REV A 8/6/2015

POC2 CONTROLLER	
Doc Number	<Doc>
Date	Thursday, August 06, 2015
Sheet	1 of 1

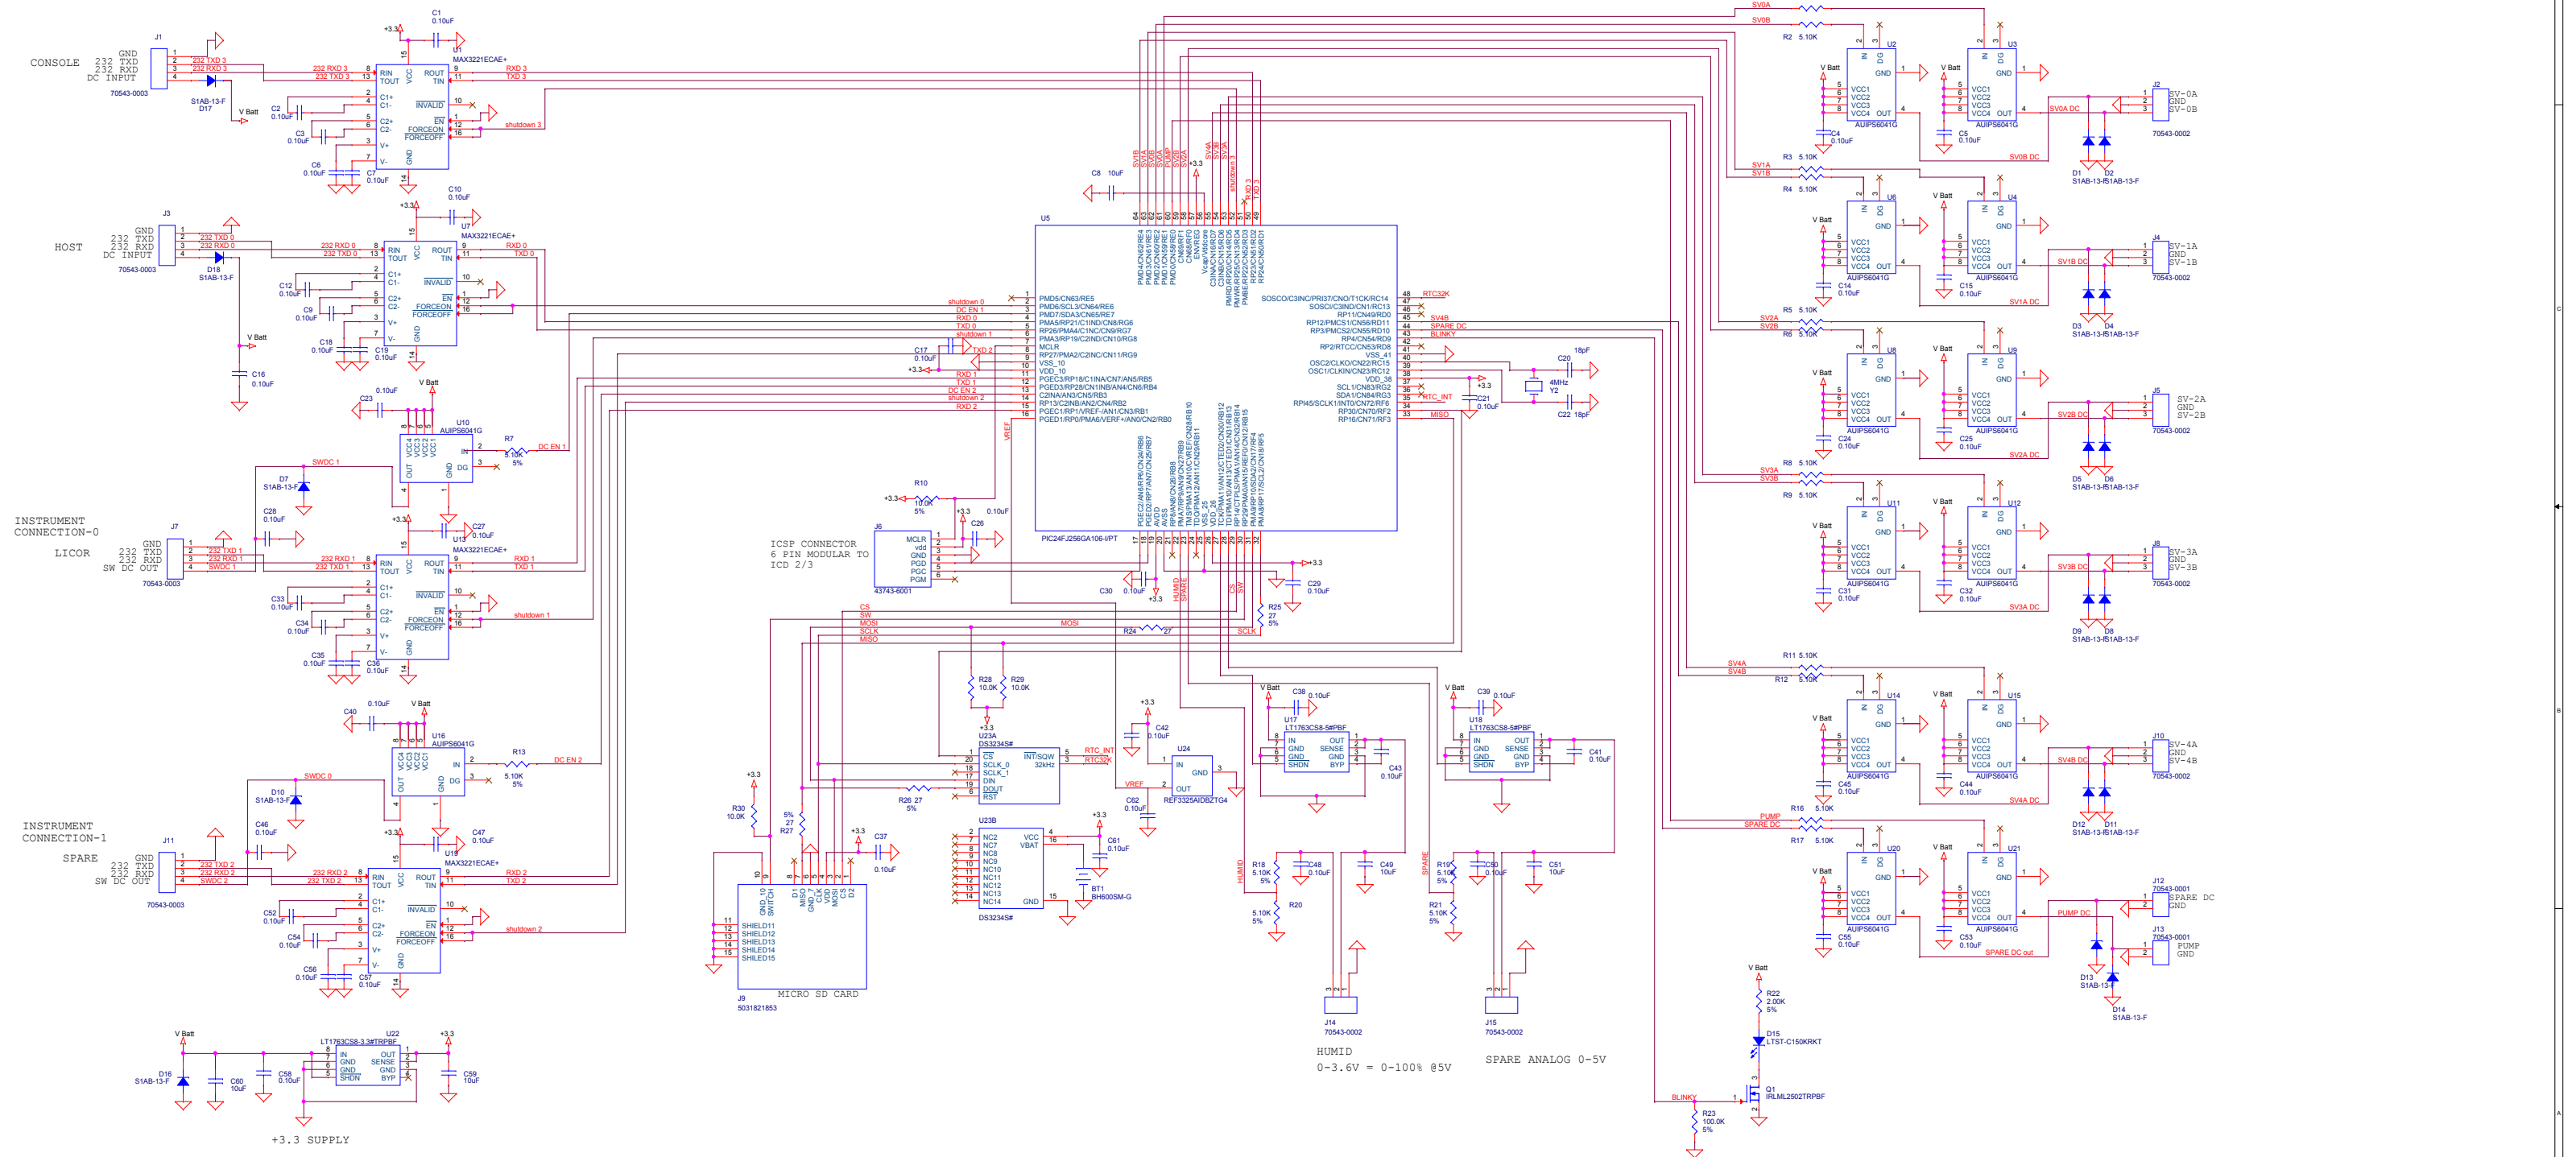
NOTES:	
REV	DESCRIPTION
A	10 uf cap replaced by 490-1891-1-ND Add D17, di8 input isolation diodes Connect 3.3v supply(U22) pin 5 to Vbatt Remove 32k oscillator (Y1, C11, C13) Connect RTC(U23) pin 3 to PIC24 pin 48 Connect RTC(U23) pin 5 to PIC24 pin 35 Connect U24 2.5v to VREF input Pin 16 Change U24 to +3.3v input Change TXD2 to U5 pin8
